RFI #: 85
 Date: 3/23/2012
 Job: EB-02 Keller Springs Lofts
 Phone: 877-777-5115

Subject: Water heater types

RFI #: 124
 Date: 5/21/2012
 Job: EB-02 Keller Springs Lofts
 Phone: 877-777-5115

Subject: A4 Unit Questions

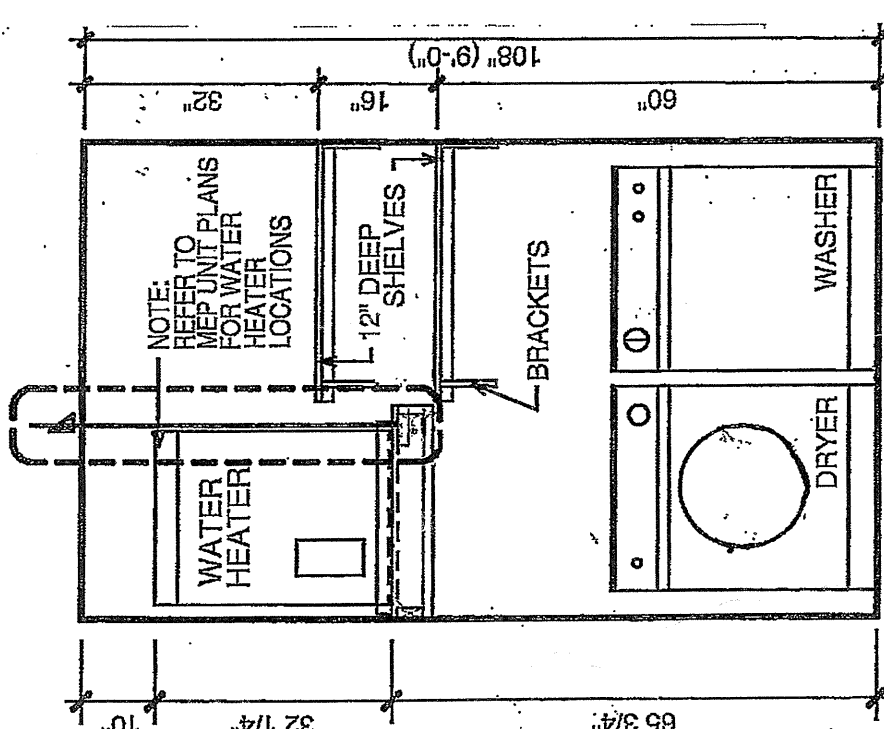
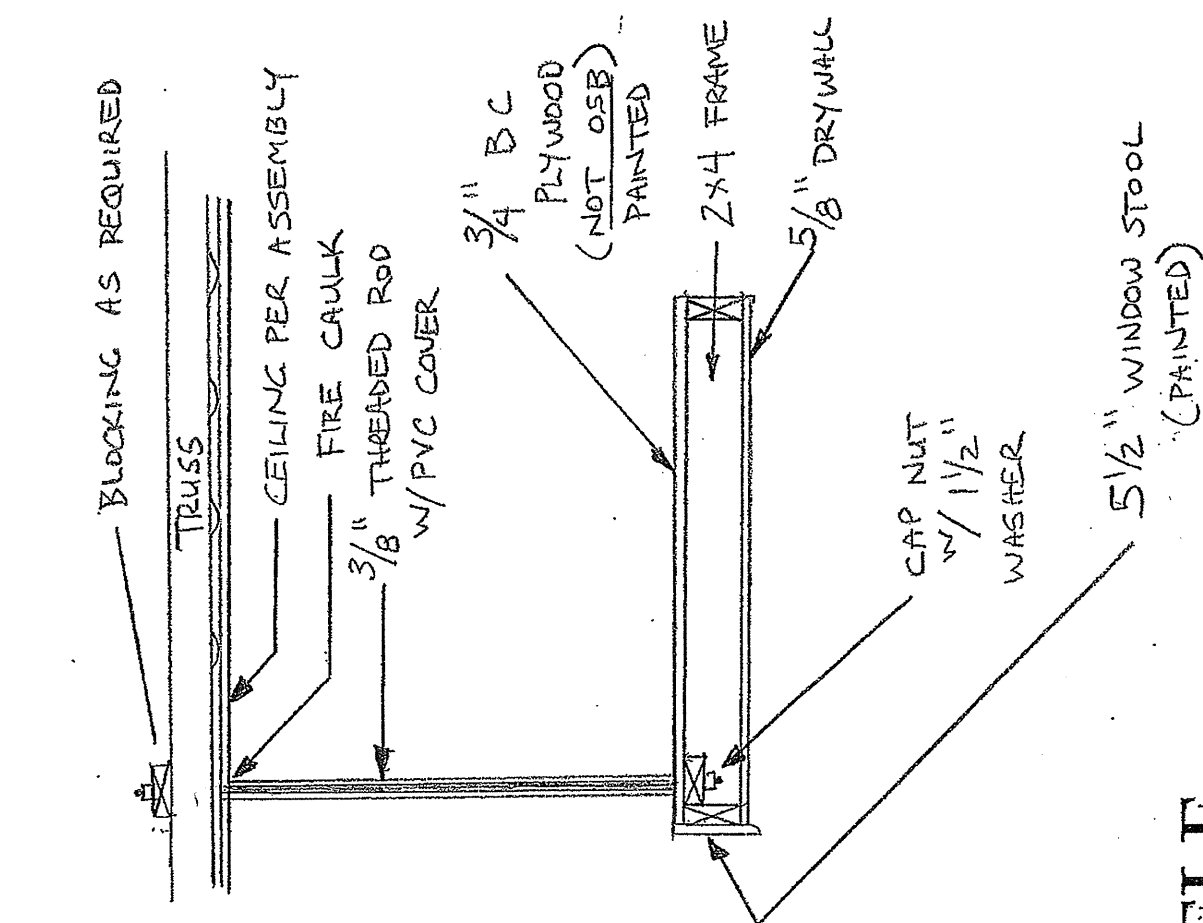
Subject: Guest Bathroom Closet doors in the A4 and B2 units

Request: In the A4 and the B2 units the guest bathroom closet door interferes with the clothes hangers. What door mark do we need to change to?
Date Required: 4/19/2013

Response: Reverse the #5 door swing into the bath and hinged on the tub side of the opening.
